ARCHITECTURAL REVIEW BOARD STAFF REPORT

Project #/Name	ARB-2019-143: Malloy Ford Outdoor Display and Furniture Store Repurposing
Review Type	Advisory Review for a Special Use Permit and Conceptual Review of a Building Permit
Parcel Identification	045000000068A0, 045000000112B1
Location	2060 Seminole Trail
Zoned	Highway Commercial (HC), Entrance Corridor (EC)
Owner/Applicant	Malloy Properties III LLC C/O Malloy Companies LLC/BRW Architects (David Timmerman) and Valerie Long
Magisterial District	Rio
Proposal	To demolish a portion of the existing building; to establish outdoor sales/storage/display of vehicles in the area previously occupied by the building, and to renovate the exterior of the remaining portion of the building.
Context	The surrounding area is a heavily developed commercial corridor. Automobile dealerships with vehicle display are located nearby, including the Malloy Ford property on the adjacent parcel to the north.
Visibility	The proposed development will be readily visible from the Entrance Corridor.

ARB Meeting Date	January 21, 2020
Staff Contact	Margaret Maliszewski

Figure 7.7. An illustration of surface parking with a landscape buffer. 1 center of the wider buffer might be replaced with a low hedge.

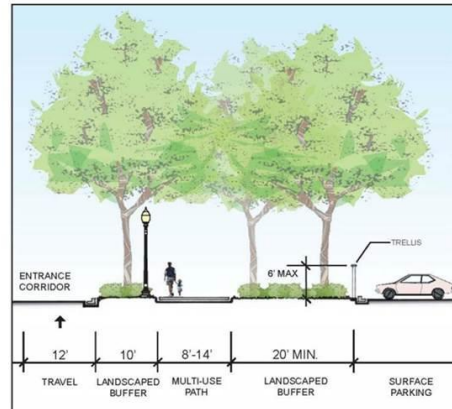
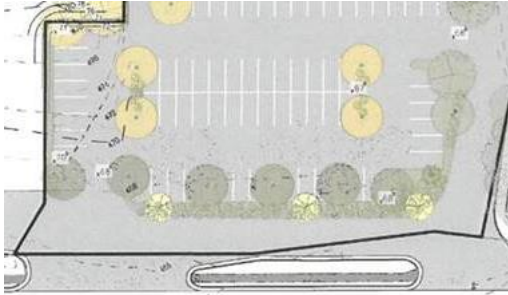
There are some inconsistencies between the Places29 diagram and the existing condition (primarily, the existence of the access road)

but it is clear that the intent of the Places29 requirement is for parking areas to be well-screened. Expanding the new planting island along the parking to a minimum width of 10' (but preferably more), placing shade trees in that planting island, and adding trees and shrubs in the existing island adjacent to the

sidewalk (with VDOT approval) would come closer to meeting the intent of the Places29 plan and would begin to offset some of the visual impacts of the increased parking area located close to the corridor. 	
33	Landscaping along interior roads: a. Large trees should be planted parallel to all interior roads. Such trees should be at least 2½ inches caliper (measured six inches above the ground) and should be of a plant species common to the area. Such trees should be located at least every 40 feet on center.	Trees are proposed along the south side of the travelway adjacent to the Malloy showroom site at the required size and spacing.	None.
34	Landscaping along interior pedestrian ways: a. Medium trees should be planted parallel to all interior pedestrian ways. Such trees should be at least 2½ inches caliper (measured six inches above the ground) and should be of a species common to the area. Such trees should be located at least every 25 feet on center.	A sidewalk extends 150' along the EC-facing side of the building, and beyond for a total length of 195'. Trees are shown along the building at 25' on center.	None.

- a. The minimum depth of the planting island adjacent to the easternmost parking row must be 10'. The depth must be increased as necessary to avoid damage to trees from tractor-trailer movements.

- b. The planting island adjacent to the easternmost parking row must contain a minimum of 4 large shade trees, 2½" caliper at planting, interspersed ornamentals, and a row of shrubs.

- c. Trees and shrubs must be added in the existing island adjacent to Rt. 29.
 - d. Interior parking lot trees must be added in the double- and triple-parking rows.
